Response to a Request for Further Information

**Site C, College Lane, Greenogue, Rathcoole, Co.
Dublin**

South Dublin County Council Reg. Ref.: SD21A/0200

Figure 2.2: Extract from Proposed Site Plan Proposed as Part of Planning Application Stage (Left) and the Site Plan Now Proposed at RFI Stage (Right)

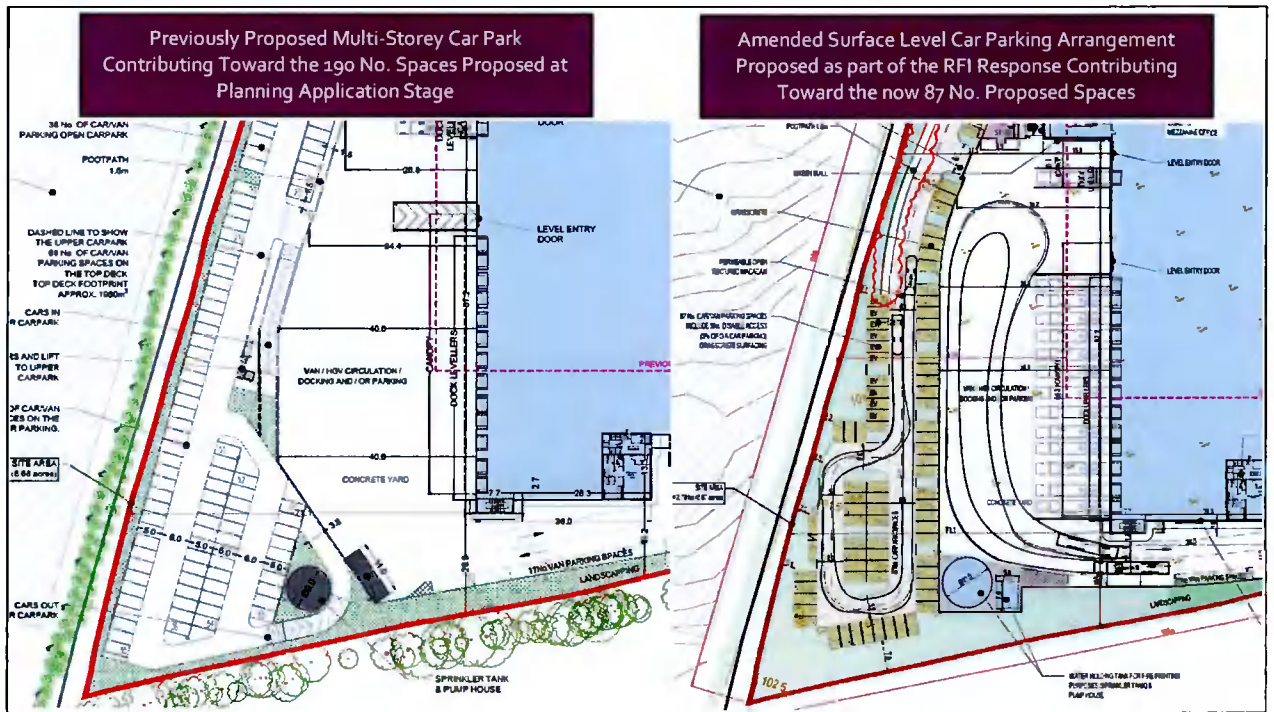
(3) The proposed increase in floor area results in the proposal to provide a multi-storey car park at this location. The Planning Authority has serious concerns regarding the proposal for a multi-storey car park on this site and in the vicinity of this site. Policy directs people intensive enterprise and employment into lands zoned for town centres and village centres and in location to good public transport. This is not the case at this location. A development requiring a multi-storey car park should be directed towards towns and villages. The granting of a multi-storey car park would be undesirable at this location and should be omitted. A revised design, site layout plan, and supporting reports shall be submitted to address all the points made.

A reduced provision of car parking is now proposed and the multi-storey element has been removed from the proposal in place of a surface-level car parking arrangement. This has also allowed for an increase in the provision of SuDS measures and landscaping on the site. Some 87 No. spaces are now proposed, reduced from the 190 No. car parking spaces proposed at planning application stage (and also reduced from the 119 No. already permitted at the site). An extract from the Site Plan proposed at Planning Application stage and the Site Plan now proposed at *Request for Further Information* stage has been included below:

Figure 2.3: Location of Proposed Bicycle Parking on Site Plan

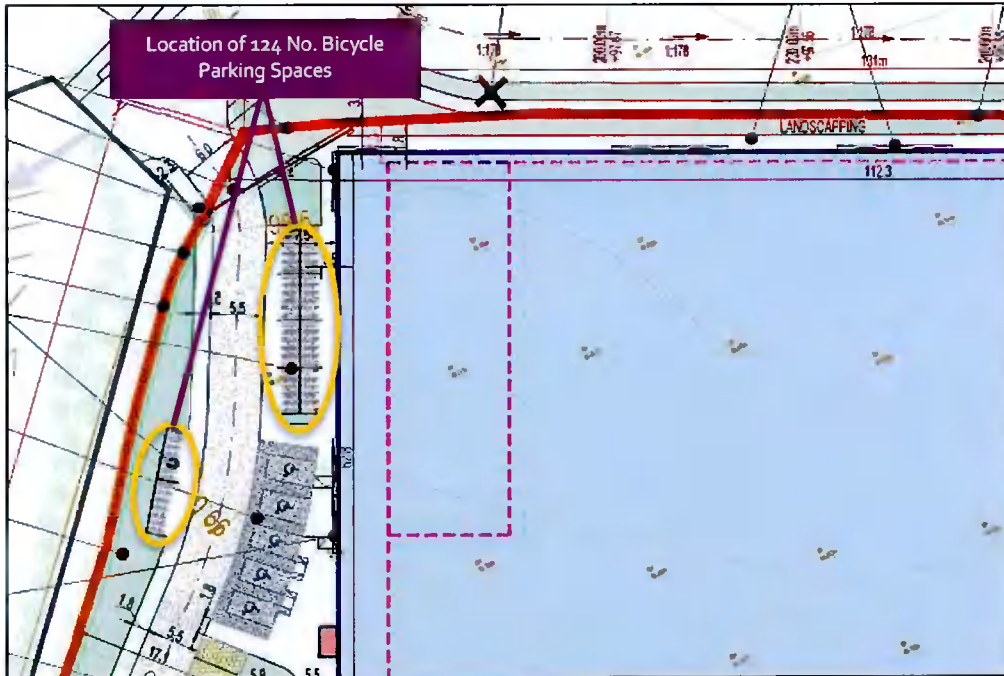
(4) 72 permitted bicycle spaces are proposed. Under the County Development Plan one space is required per 200sq.m of additional floor space. In this instance this is 70 additional spaces. The applicant is requested to provide a total of 142 covered bicycle spaces. A revised layout plan shall outline the location of these 142 spaces.'

As a result of the revisions to the proposed floor area, some 124 No. bicycle parking spaces are now proposed as part of the *Request for Further Information Response* in accordance with the *South Dublin County Council Development Plan 2016-2022* where one space is required per 200sq m of floor space. Given 24,704 sq m of gross floor space (not including staff facilities and plant room areas) is now proposed at *Request for Further Information* stage some 124 No. bicycle parking spaces are required. The 124 No. proposed meets this requirement. An extract from the proposed Site Plan has been included in the Figure below showing the location of the 124 No. proposed bicycle spaces.

Figure 2.5: Proposed Bus Network New Routes with Subject Site Identified by a Star

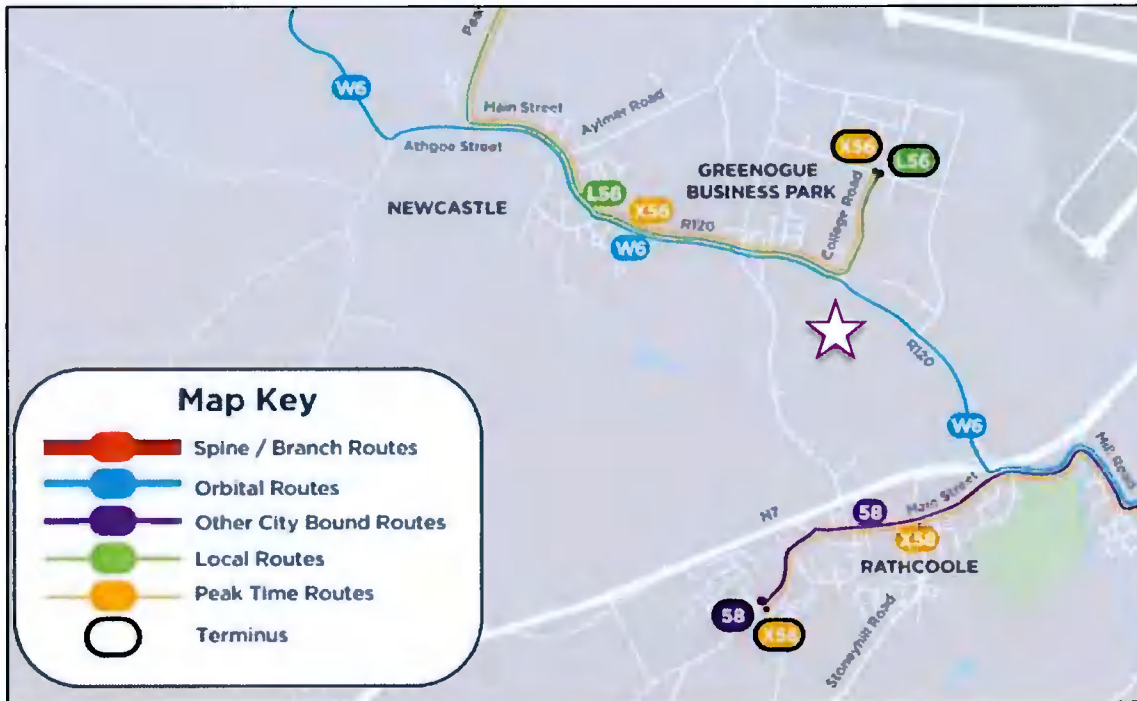
(3) Submit a robust justification for the quantum of car parking proposed on site having regard to County Development Plan Policy and an assessment of access to public transport in the area. The applicant shall note that the Development Plan parking standards are maximum standards. The proposal shall commit to developing a Mobility Management Plan for the proposed development, which should continue to promote the current trends to sustainable travel modes. Details of which should be submitted as part of the response to this request.

Plans to address and improve public transport provision in the locale are afoot, in the form of the proposed Bus Connects programme which will see 3 No. bus routes along the R120 as set out in Figure 2.5 below:

Figure 2.6: Swept Path Analysis from the Southwestern Portion of the Lands

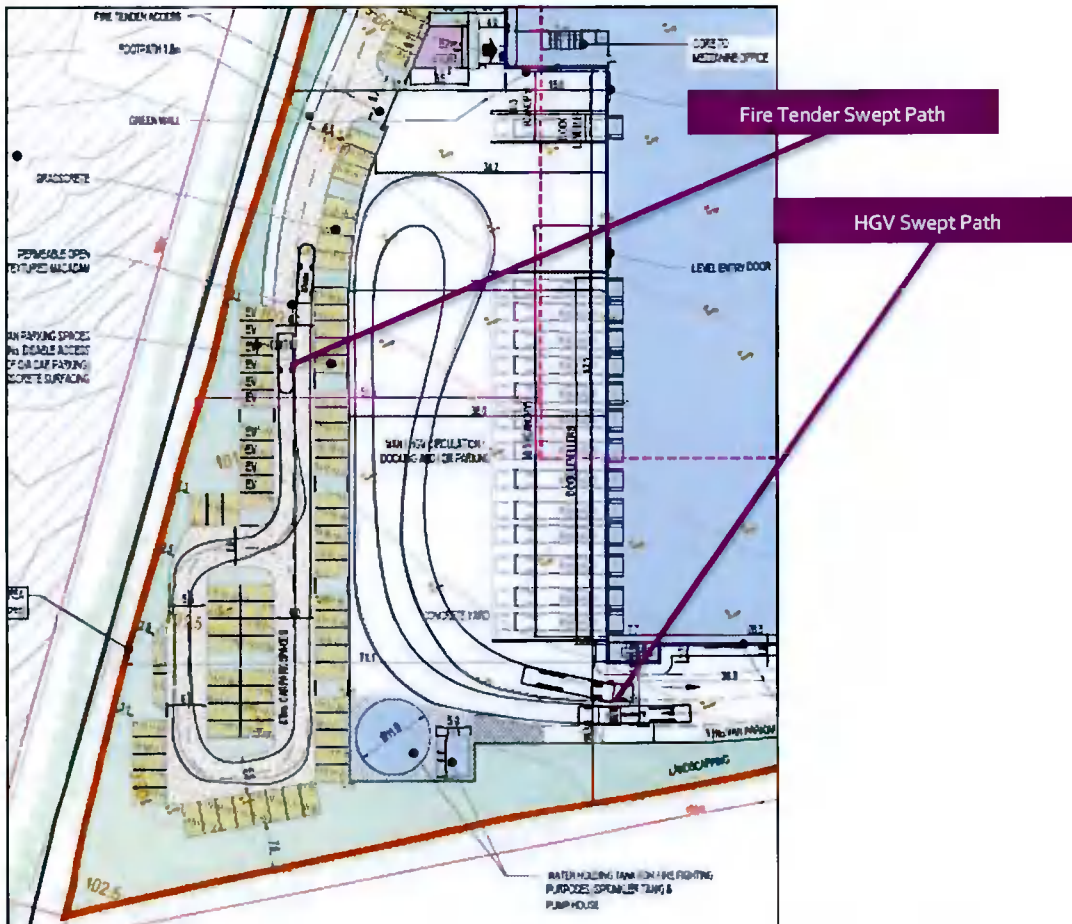
(5) A swept path analysis for fire tenders and HGVs showing access to all required locations of the site shall be submitted and agreed by the Planning Authority. (Taking note of the requirement to provide Green Infrastructure throughout the site).

An extract of the Site Plan drawing, prepared by Kavanagh Burke Consulting Engineers, has been included below for the southwestern and southeastern portion of the site below:

Figure 2.8: Electric Vehicle Charging Facilities

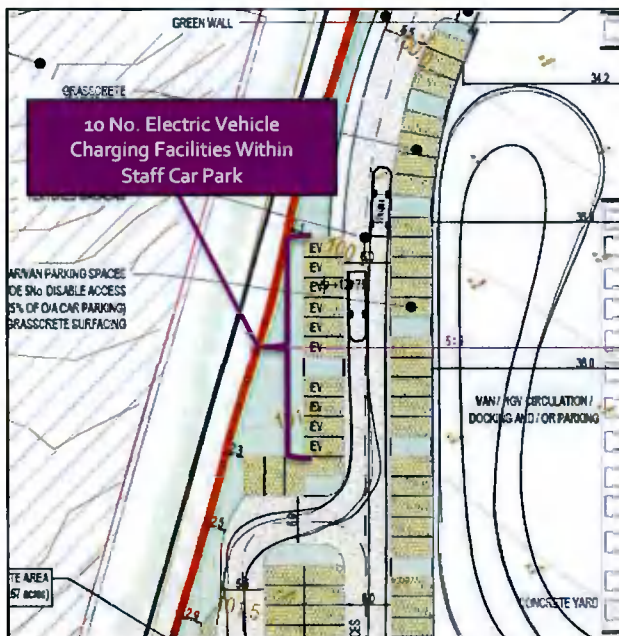
(6) A revised layout showing the Electric vehicle parking provision and facilities for charging electric vehicles within the proposed staff car parks.'

The location of the 10 No. EV Car Parking Spaces has been shown below on the Site Plan drawing (Drawing No. D1658 D2) prepared by Kavanagh Burke Consulting Engineers:

Figure 2.9: Location of Proposed Green Roof

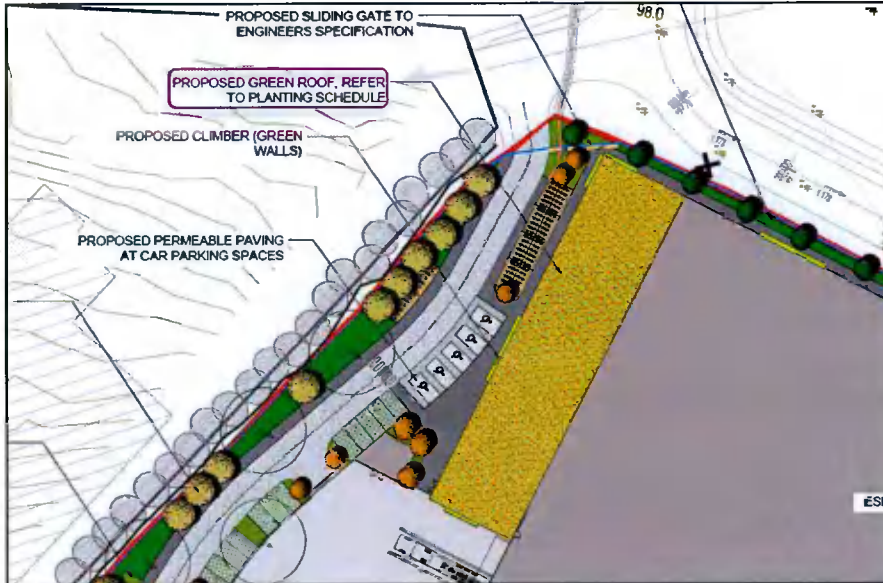
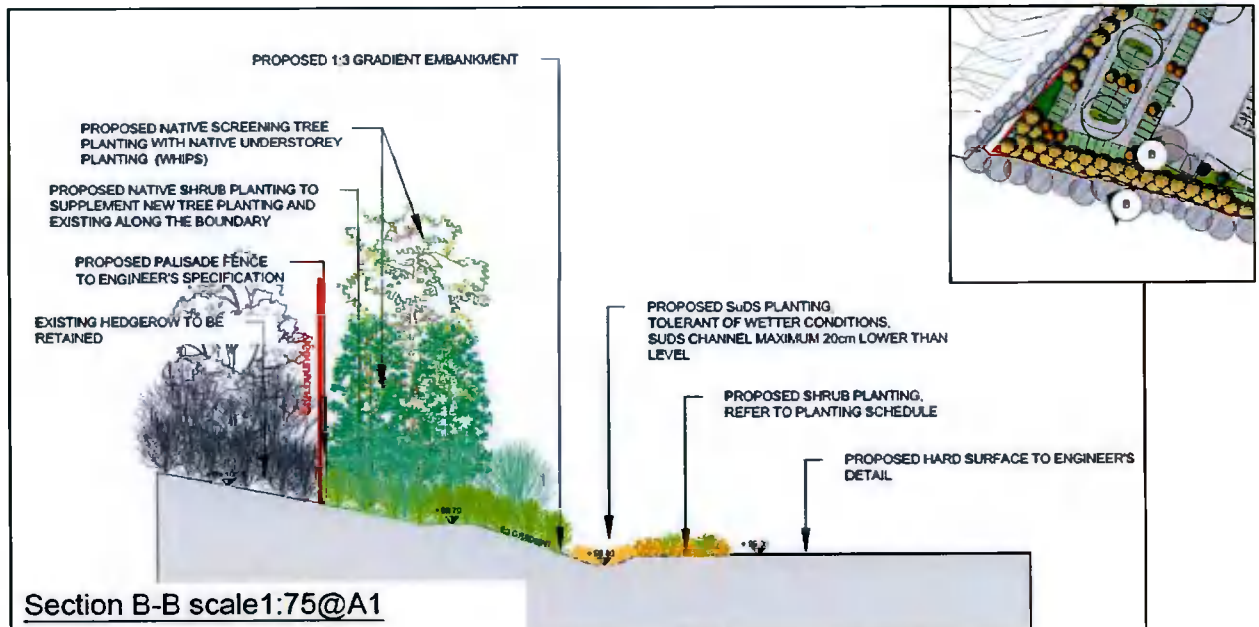
(a) A green roof/part green roof (over the office building)

One such redesign element is the proposed green roof provided over the office element of the proposed warehouse. An extract from the Landscape Masterplan (Drawing No. CER-JBAI-XX-XX-DR-L-0002) prepared by JBA Consulting has been included below showing the location of the proposed green roof:

Figure 2.11: Initial and Revised Landscape Masterplan

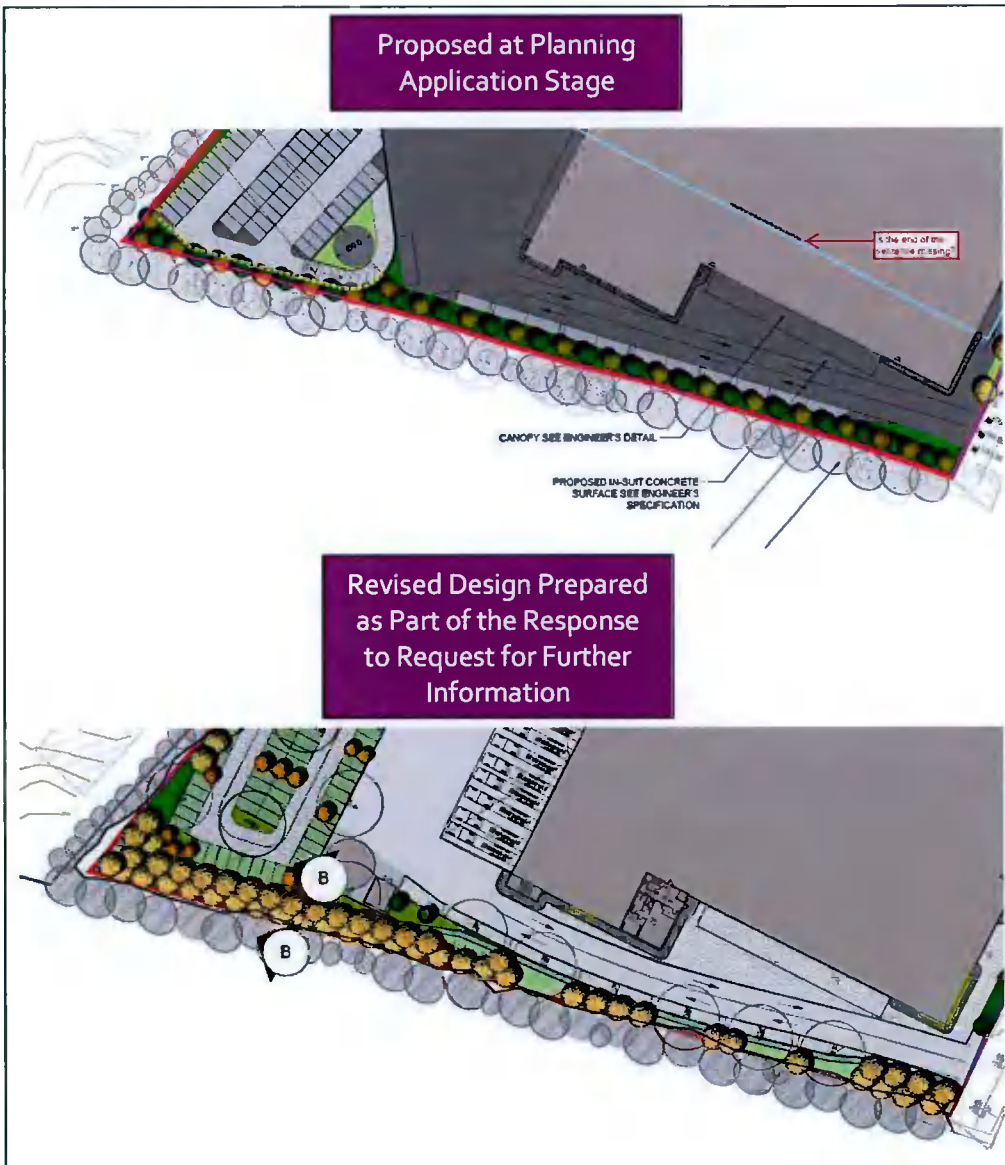
(c) Increased planting, berms and greened-buffer zones around the perimeter of the site, especially the southern boundary.

The southern boundary has received particular attention by the Design Team in this *Response to Further Information Request*. Increased planting has been provided along the southern boundary with proposed native screening tree planting and proposed native shrub planting. An extract from the Landscape Masterplan proposed at Planning Application stage and the revised design prepared as part of this *Response to Request for Further Information* have been included below.

Figure 2.13: Initial and Revised Landscape Masterplan

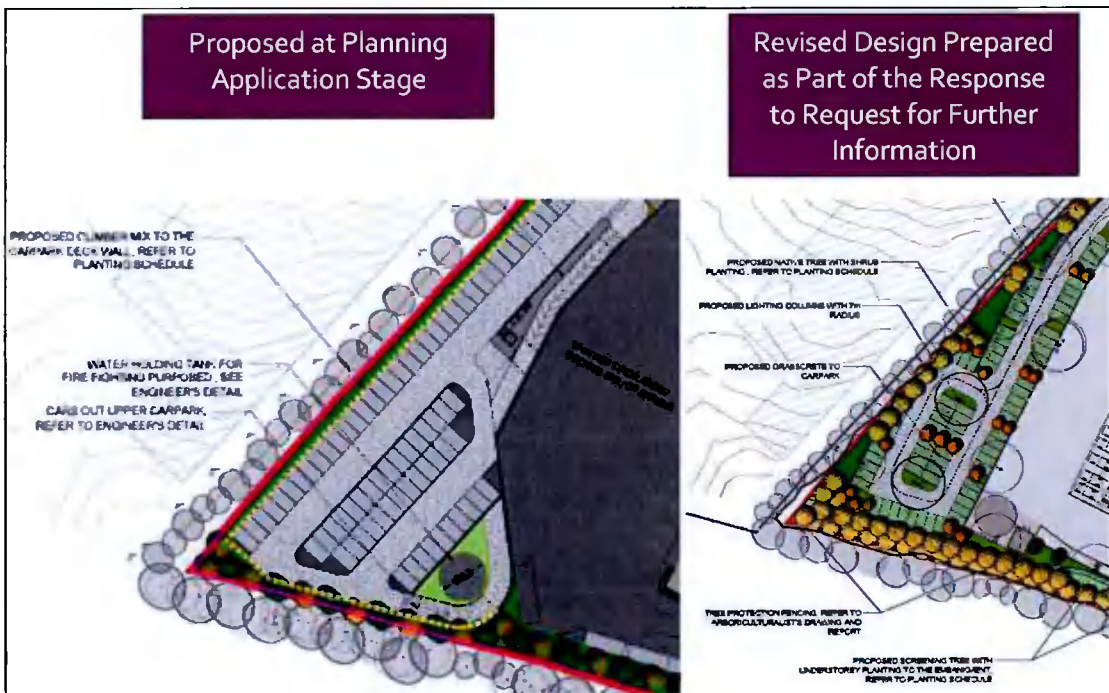
(b) Street trees along the eastern boundary access road and within the car park shall also be a minimum 20-25cmg at planting.

Along the eastern boundary access road, street trees have been provided for as shown in the Landscape Masterplan (Drawing No. CER-JBAI-XX-XX-DR-L-0002) prepared by JBA Consulting.

With regard to within the car parking area, increased amounts of planting have been provided for as shown in the Figure below, ensuring that the warehouse scheme is not legible as a hard surfaced environment but instead is legible as a high quality designed warehouse scheme.
